SUBJECT: Records to remaining open issues re DCRDR, including upgraded task analysis & color convention in control room. Safe shutdown analysis demonstrates that safe shutdown can be accomplished w/o using HPCI sys.

SUSQUEHANNA STEAM ELECTRIC STATION
DETAILED CONTROL ROOM DESIGN REVIEW
PLA-2737 FILE A17-19

This letter is provided in response to the remaining open issues regarding the Detailed Control Room Design Review. The enclosed information reflects discussions between PP&L and members of your staff during a meeting at the Susquehanna SES site on September 22, 1986.

EMERGENCY RESPONSE CAPABILITY IMPROVEMENT SCHEDULE

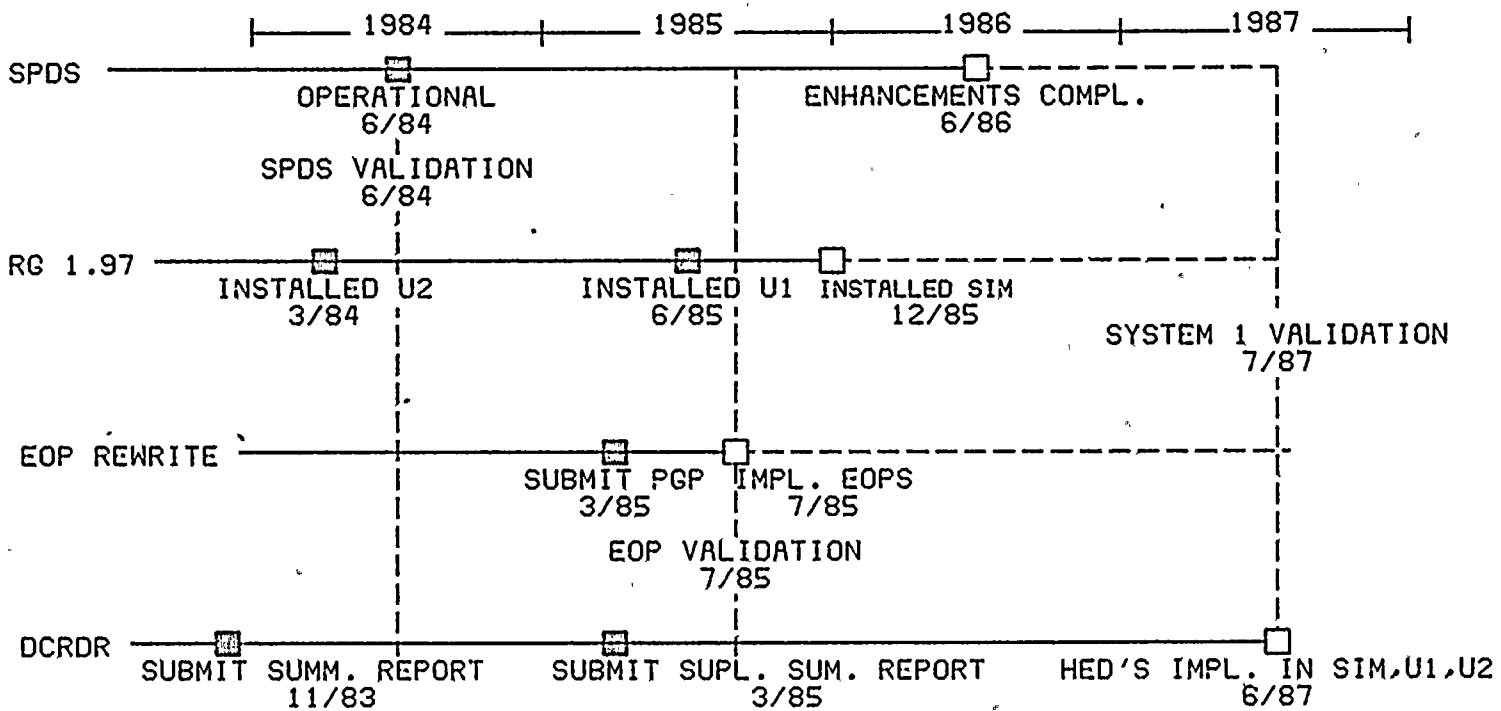
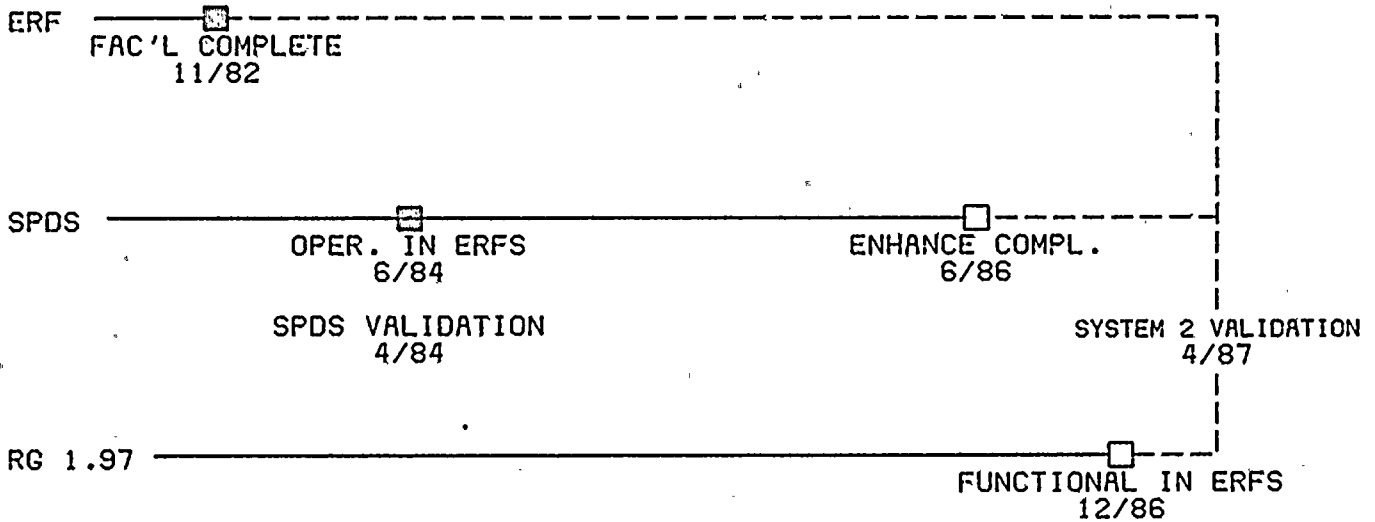
These methods involved development of an integrated schedule/plan (see Figure 1). Each element was then developed independently using the methodology listed on the table below. Integration and conformance to NUREG 0737 criteria are assured by the validations listed on the same table. The process was accomplished by dividing the emergency response capabilities into two systems: System 1, the Accident Mitigation and Prevention System, revolves around the control room operator and involves integration of the operating shift, the control room (including all enhancements), the emergency operating procedures and operator training. System 2, the Emergency Plan Response System, revolves around the emergency personnel and involves the integration of emergency personnel, emergency response facilities (including all enhancements), the Emergency Plan Implementing Procedures, and emergency plan training. Separate validation tests were performed on separate elements of each system and will be performed on the integrated elements of each system.
